**Case No. P20-20
1007 N. Court St.**

CITY of MEDINA
Planning Commission
December 10, 2020 Meeting

Subject: Site Plan Review & Conditional Zoning Certificate – site reconstruction for new restaurant with drive-through

Date: November 25, 2020
To: Planning Commission
From: Patrick Patton
RE: PC 20-20 Proposed Chick Fil A restaurant at 1007 N. Court St.

SITE PLAN

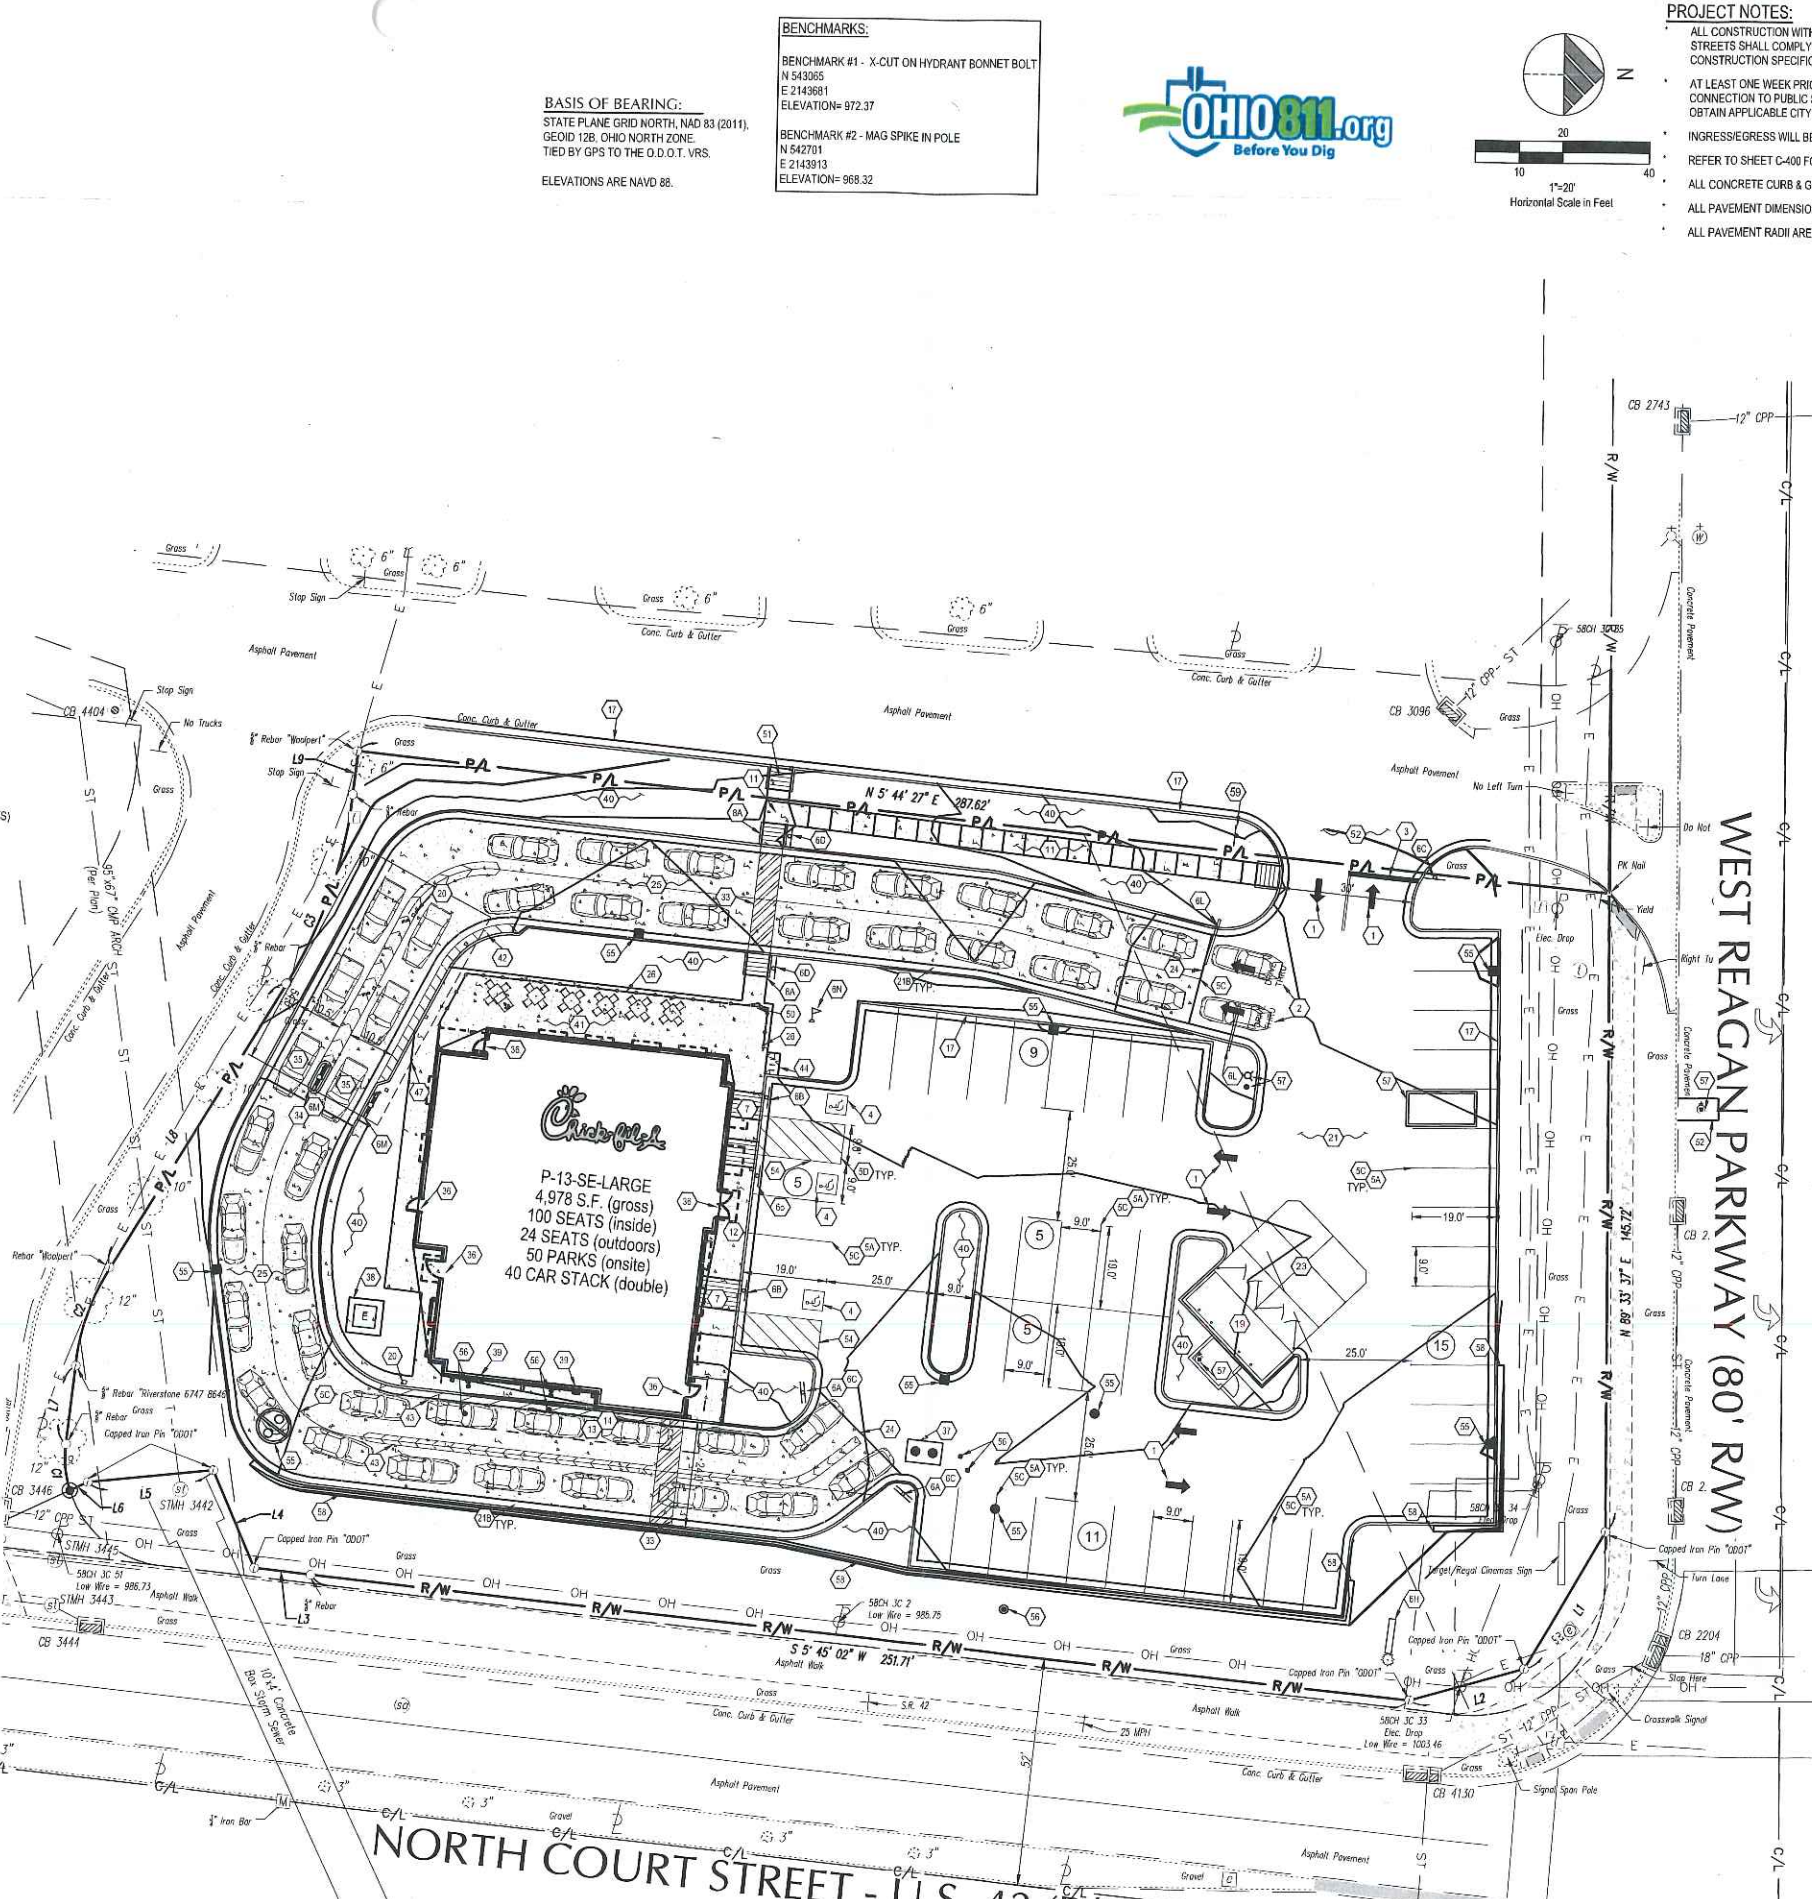
The proposed drive-through facility complies with the applicable drive-through requirements of Section 1155.10 of the Planning and Zoning Code. Although, the proposed double lane drive-through is fully within this property, the site's access drive in the northwest corner of the property is quite close to the main Reagan Pkwy entrance to the north-south private drive for the commercial superblock in which the subject property is located. The City of Medina Engineering Department had initial comments on the submittal (see attached Engineering comments dated November 25, 2020) and then later discussed these comments with the applicant.

The solution is to mitigate excessive queuing toward Reagan Pkwy by introducing a right-in only design (for the drive-through entrance) to the site's entry drive from the superblock's private north-south drive to specifically manage/direct traffic entering the drive-through entrance. This will force excessive off-site drive-through queuing southward onto the private north-south drive (see attached applicant response letter dated December 3, 2020). Additionally, the applicant stated signage will be added to this portion of the site to provide instruction regarding the required traffic management and the business operator will work to provide active on-site vehicle queuing management as well.

Upon reviewing the site plan submitted for the above captioned project, I would like to advise the Commission about my concern regarding traffic impacts due to the proposed project.

The site plan indicates that the entrance to the restaurant will be located adjacent to the northern edge of the property. This entrance is located only a short distance from the entrance to the shopping center off of West Reagan Parkway. While the site plan indicates that a total of 40 vehicles can be stacked within the proposed drive thru lanes, our concern is that this may not be enough capacity to prevent vehicles attempting to go to the restaurant from backing up onto West Reagan Parkway.

While we acknowledge and appreciate the information provided from other locations, we are still concerned about the potential of traffic backing up onto West Reagan Parkway. West Reagan Parkway is a major collector street, and the location of the shopping center entrance on West Reagan Parkway is in close proximity (approximately 270 feet) to a federal route (US 42/North Court Street).

The intersection of West Reagan and North Court is one of the busiest in the City. It, along with the 100 block of West Reagan, has consistently been one of the highest accident rate locations in the City. Access to the shopping center at the West Reagan entrance is permitted from both east bound traffic (turning right) and west bound traffic (turning left). Because of the significant amount of traffic on both streets throughout the day, and the potential that both west bound and east bound traffic could be affected by vehicles backing up onto West Reagan, we are particularly sensitive to this concern.

Because of this concern, I would request the Commission require that the applicant conduct a traffic impact study of this site to investigate this issue. That study should review known traffic generation volumes generated by Chick Fil A's along with traffic volumes and potential impacts (delays) on West Reagan Parkway. I would hope that the study would be able to identify potential modifications to the site plan and/or other improvements that would help mitigate the possibility of traffic impacts on the adjacent streets.

Please be advised that after review of this traffic impact study, the City may require modifications to the submitted site plan to address these issues.

The provided data taken from the Solon Traffic Study provides the information requested for this site. The anticipated drive-thru stack during the PM peak hour is 23 vehicles. The proposed site layout over accommodates this number by providing 40 drive-thru parking stall queuing spaces onsite. Additionally, CFA is always looking for ways to reduce the time spent in the drive-thru to help keep the stacking drive-thru cars as low as possible. This is done by staging employees within the drive-thru lanes taking orders and payment. CFA has updated their buildings, and the drive-thru window has been replaced with sliding glass door that allows employees to walk orders to multiple vehicles at the same time. CFA prides itself by setting the bar for the customer's drive-thru experience.

The site layout maximizes the number of cars that can que in the drive-thru lane. This layout reduces the possibility of vehicles within the site backing into the shopping center or backing the traffic traveling from the shopping center to West Reagan Road. Additionally, a proposed sign has been added near CFA's site entry stating "DO NOT BLOCK DRIVEWAY". This is seen as Keynote Number 59 on Sheet C-200, Site Plan. The additional of this sign should keep the access open reducing the impact of a backup from West Reagan into the shipping center cross access drive.

During our discussion we touched on both the site limitations and history of the site and adjacent ODOT improvements. Introducing a limitation of right turn only into the site to further minimize impact on the surrounding public and private roads. This can be seen in the quick sketch below with the use of a raised curb. The formal plan revision has not been completed and may result in minor site adjustments.

CFA understands the opening of a new store will generate excitement and typically draws a larger crowd that later reduces to a more standard number of drive-thru cars during the peak hours. As discussed, CFA can provide a letter or plan for the store opening that addresses a larger than typical volume of traffic during the stores opening days.
